# Proposed changes to P-37

Summary of suggested changes to P-37

Sample Layout

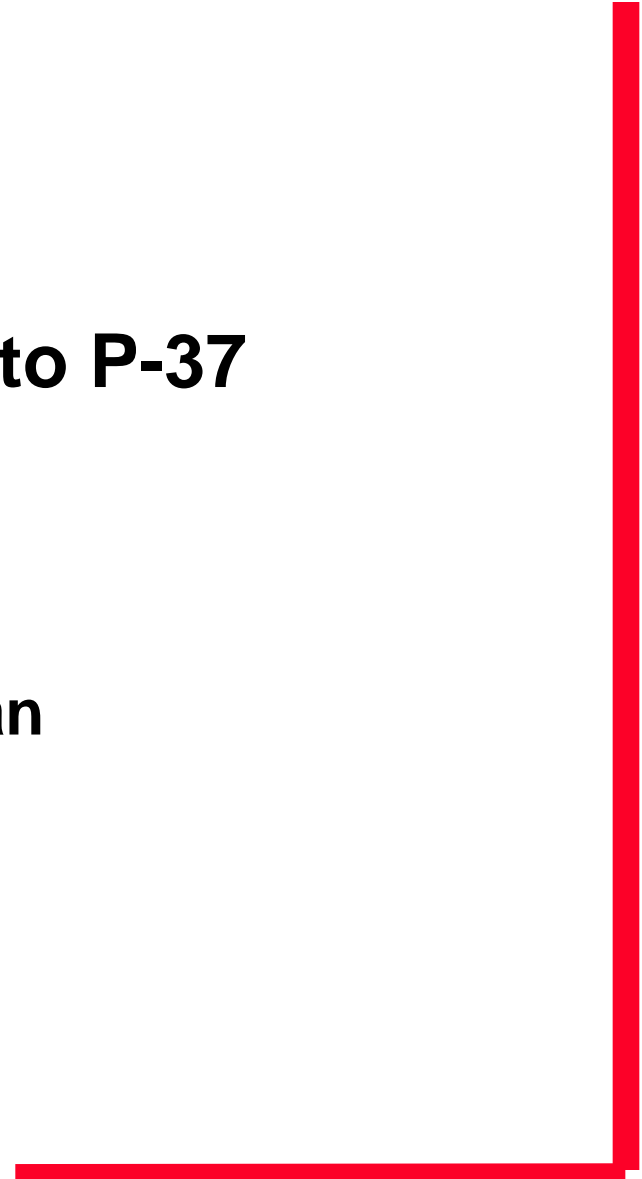
TRU is determined by comparing the system transmission for all points on the reticle

❖ **The system transmission is calculated by multiplying all the reflectivity curves of the PO mirrors and mask**

❖ **For a L-mirror system, calculate the effective transmission T for each point on the reticle by taking the sum of the product of the PO mirrors and reticle**

❖ **The transmission for each point is compared to each other**
